Site Location & Context

The site is known as 5-29 Kumbatine Crescent (3-23 Hillview Road), North Kellyville.

Proposed Changes:

RE: SECTION 4.55 APPLICATION 1 Hillview Road, Kellyville DA-735/2017/JP

1. Level change	es to internal ac	cess road and	d townhouses

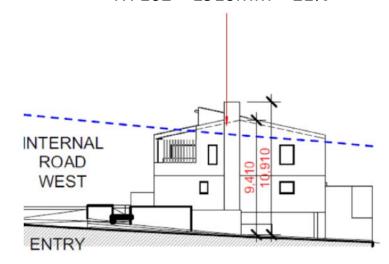
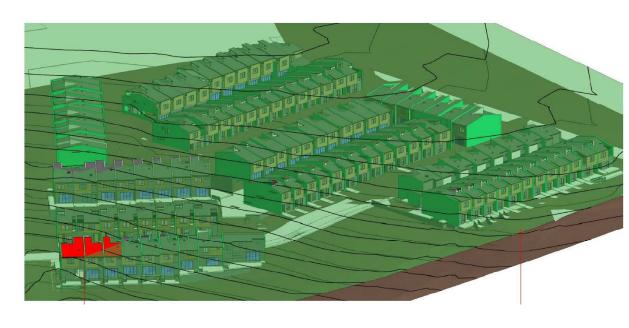
TH 102 – 1910MM – 21%

Approved DA 735/2017/JP Town House 102-104

TH 102 – 1547mm – 17%

Proposed Modification Town house 102 -104

2. New entry ramp with removal of inter basement co	onnection

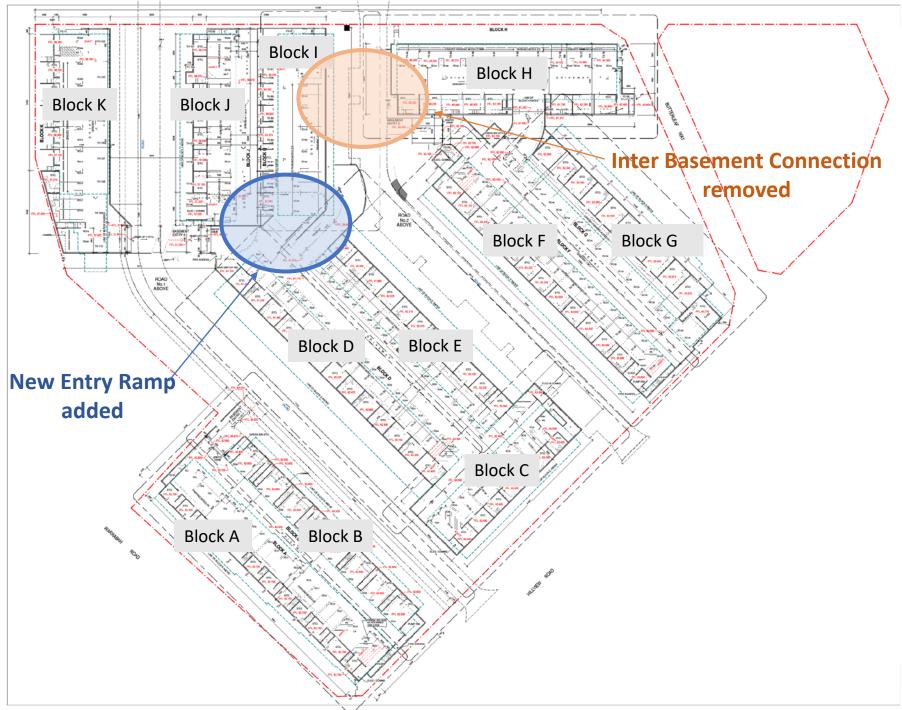
Basement		
Block	Proposed change	
Block A & B	Block A basement storage	
	increased to have clear	
	headroom and due to existing	
	road height	
Block C	Block I basement entry ramp	
	provided through block CDE	
Block D & E	Block I basement entry ramp	
	provided through block CDE	
Block F & G	No Change	
Block H	The Ramp connection between	
	Block H and I removed	
	Block H basement storage	
	increased and access from	
	basement to unit staircase	
	moved out	
Block I	The Ramp connection between	
	Block H and I removed	
	Block I Access staircase from	
	basement to unit moved out	
Block J	No Change	
Block K	Block K basement to unit's	
	entry staircase access revised.	
	Staircase moved out
